Cleveland Reasoner  
Site Vice President

January 15, 2018  
WO 18-0004

Subject: Docket No. 50-482: Response to Request for Additional Information Regarding License Amendment Request to Revise Technical Specifications to Transition to Westinghouse Core Design and Safety Analysis Including Adoption of Alternative Source Term

## Response to Request for Additional Information

Enclosure I provides a marked up floor plan of the relevant auxiliary building level

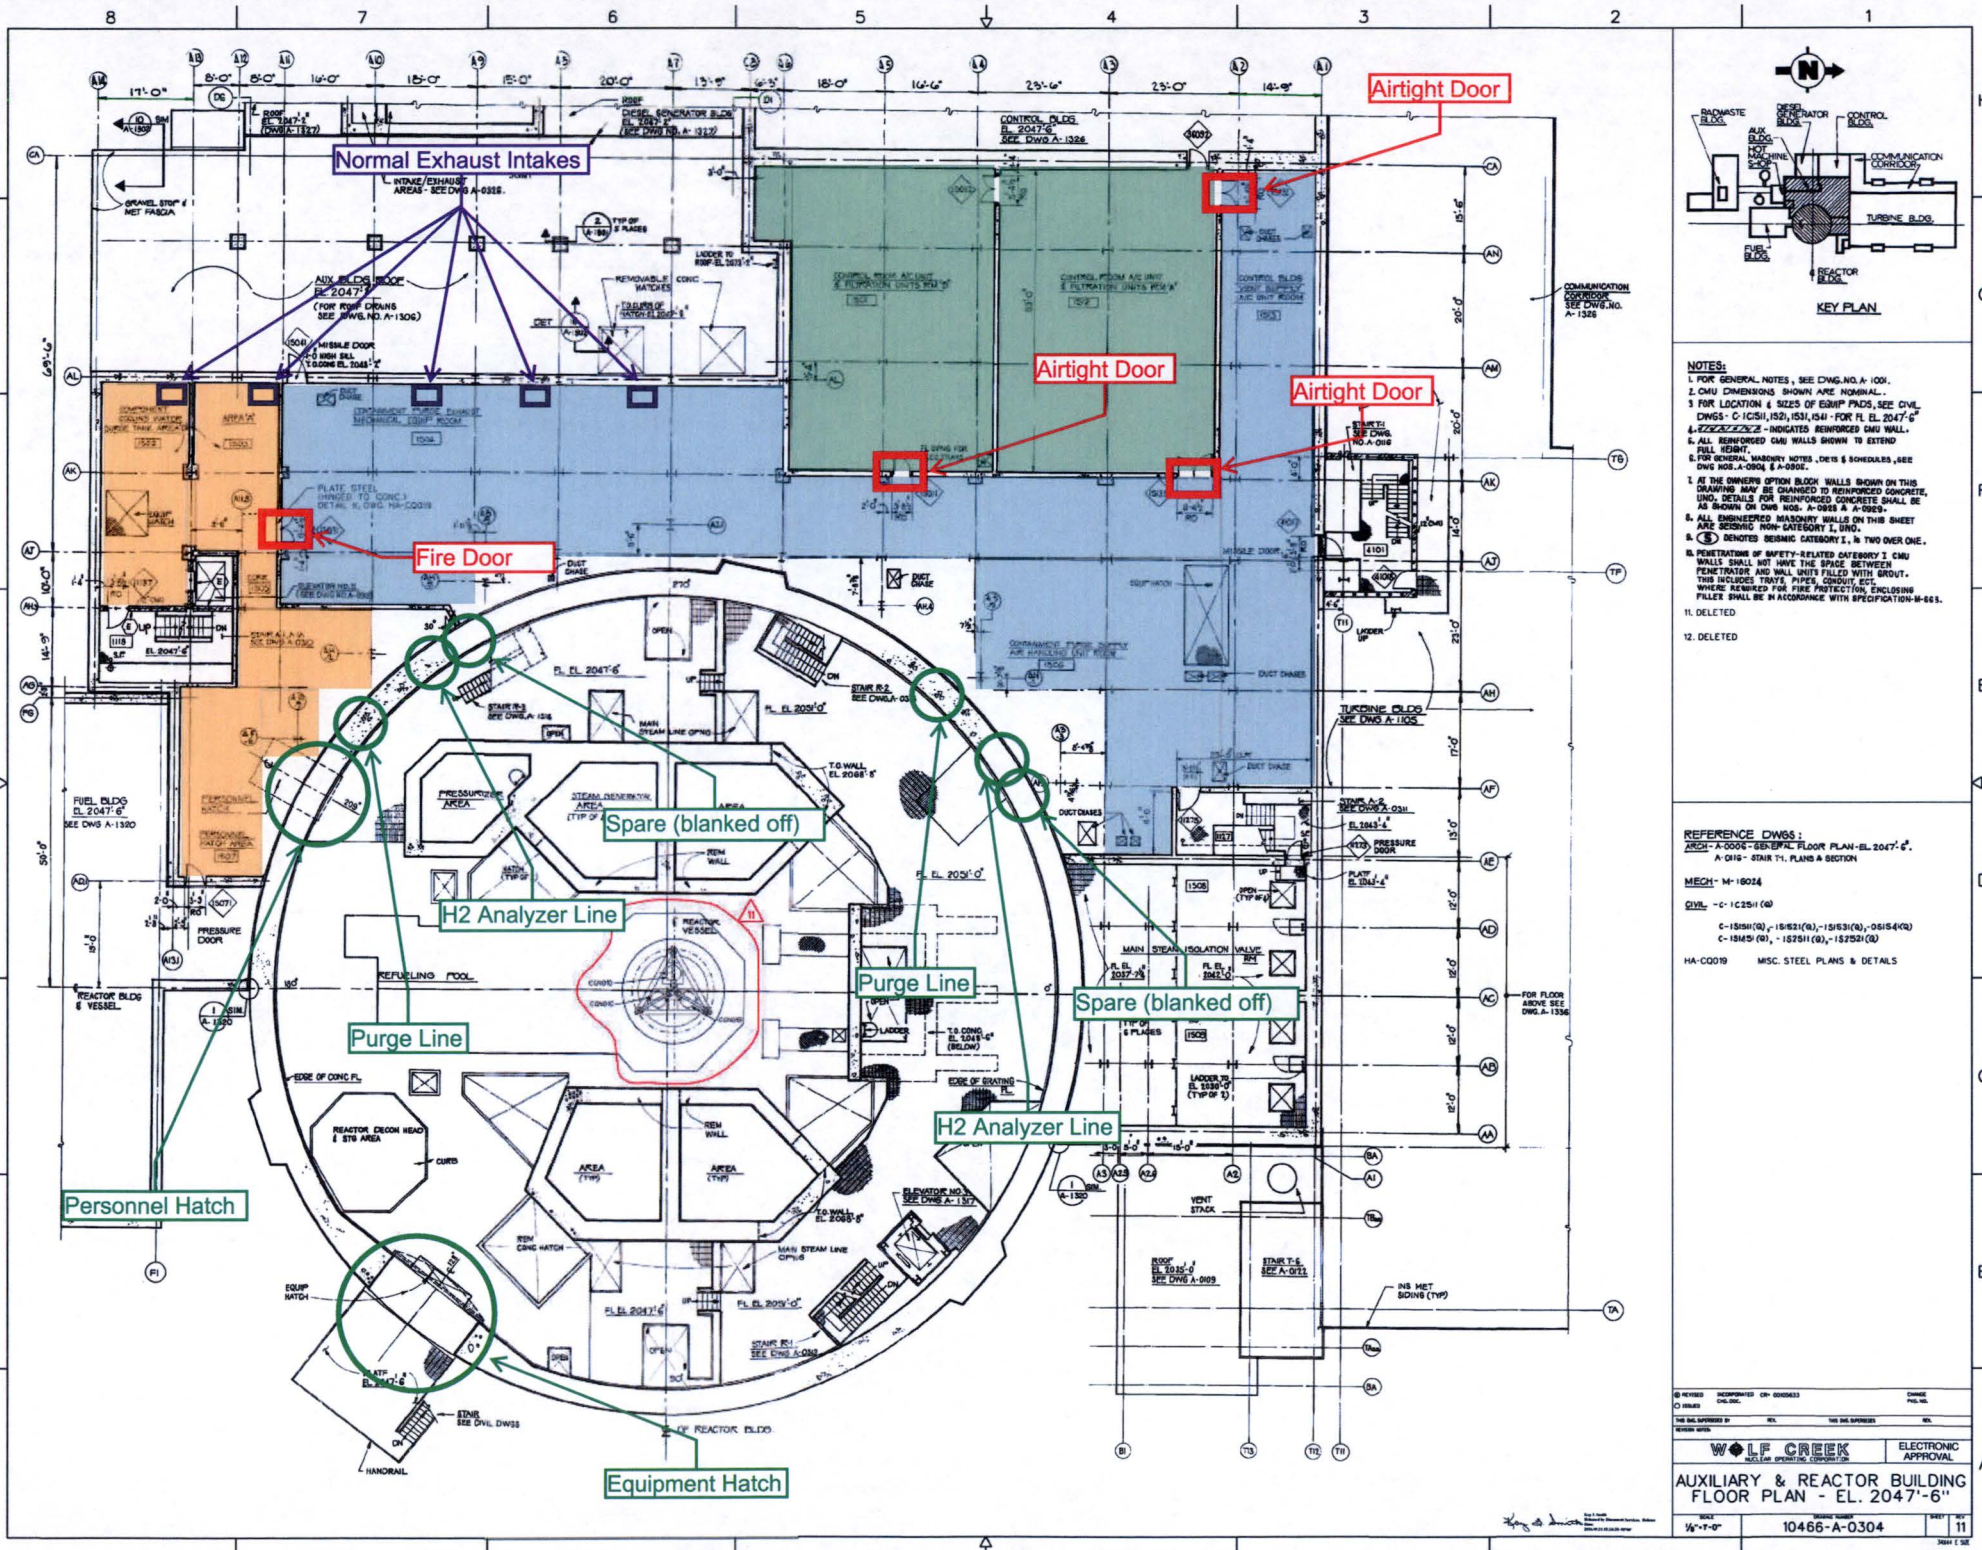
1. *Please provide justification for the assumptions made regarding the flows assumed into the auxiliary building, the dilution volume credited for the auxiliary building, and the unfiltered inleakage into the control room considering the possible environmental conditions due to winds entering the open containment penetrations or "stack effects" in the containment, or revise the assumptions and provide a justification for the new assumptions. Please consider all the different configurations for containment openings allowed by your TSs. Note that RG 1.183 allows mixing in other volumes such as the containment (up to 50 percent of the free volume) and the fuel building on a case-by-case basis, but no guidance exists for mixing in the auxiliary building.*

In order to aid the response to this question (as the accident is not typically analyzed in this manner), two figures have been enclosed with this Attachment (Enclosure I and Enclosure II). The first attachment shows a marked up floor plan of the relevant auxiliary building level. The second attachment shows all containment penetration locations.

In regards to "stack effects," as shown on Enclosure I and Enclosure II, the only two penetrations that would allow direct movement of air between the containment building and the outside environment are the equipment hatch and the auxiliary access hatch (also referred to as the emergency air lock). While the equipment hatch could be open following a FHA, as stated in the response documented within ET 17-0011 the emergency air lock will not be:

For the auxiliary building volume credited, Enclosure I shows which volumes were and were not considered. The open area between the containment and the CRE envelope is shown in blue and was credited as a mixing volume. As shown on the drawing, for simplicity and conservatism, the air volume directly next to the containment wall arc was neglected (shown in white). As the roof for this floor is 24 feet, the approximate volume of this area is greater than 178,000 ft<sup>3</sup>. This volume was reduced to 70,000 ft<sup>3</sup> to account for equipment as well as the percentage available for mixing.

As shown on Enclosure I and Enclosure II to this attachment, there are only 6 penetrations (besides the personnel air lock and the equipment hatch) above the 2047' Elevation. These six penetrations are for the purge lines (two penetrations), H<sup>2</sup> analyzer lines (two penetrations), and two blanked off spare locations. As described in the response to ARCB1-FHA-5, justification exists for crediting these penetrations as isolated during a FHA. Nevertheless, in order to conservatively account for these penetrations, a reduced mixing volume within the auxiliary building was modeled. As such, these penetrations are addressed by the analysis documented within ET 17-0011.

Figure 1: Dose Point Locations and Operator Transit Pathway

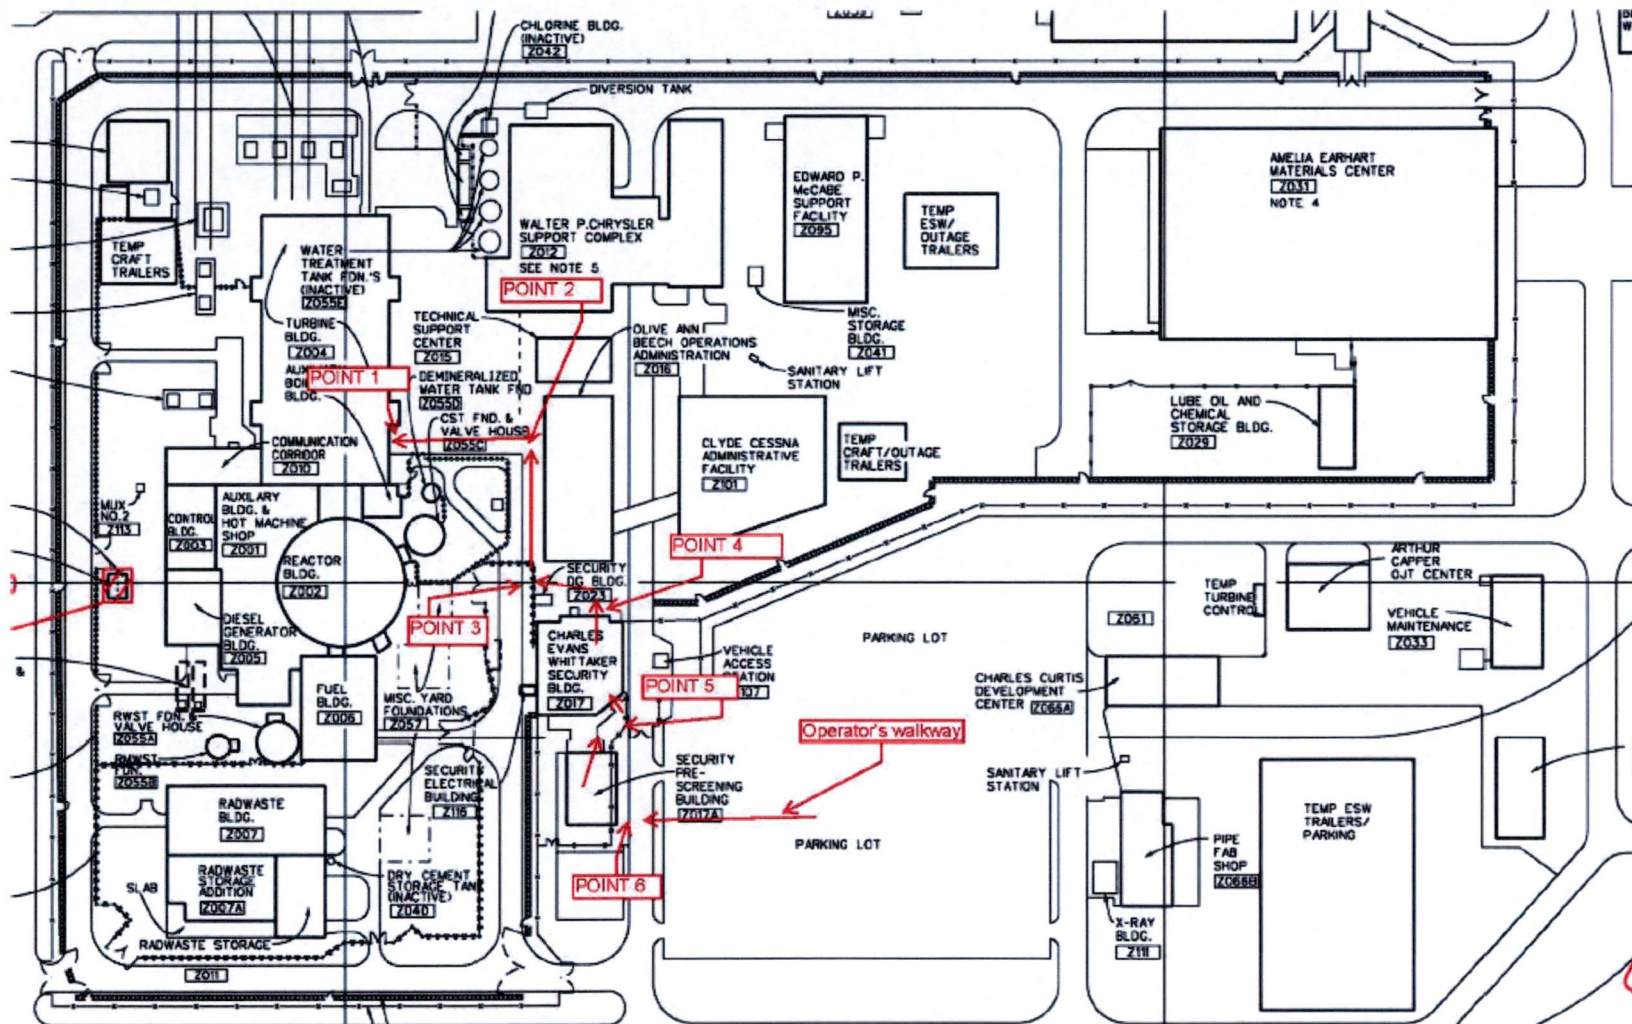
1. Please provide an analysis of the radiation dose received from ingress and egress to the control room in enough detail that will enable the NRC staff to be able to perform an independent calculation.

14. Six points along the ingress/egress path are used to determine dose rates (See Table 1 and Figure 1 for the location of these points). Atmospheric dispersion factors ( $X/Q_s$ ) are calculated for these dose points and are given in Table 2. A weighted  $X/Q$  for the entire length of the pathway is modeled for each transit based on the transit segment distance. For example, the operator is modeled to be at Point 1 while traveling the 200 feet to reach Point 2. This results in a conservative  $X/Q$  for the transit since no benefit is taken for the lower  $X/Q$  values which would result during intermediate locations in the transit segments which are further from the release points.
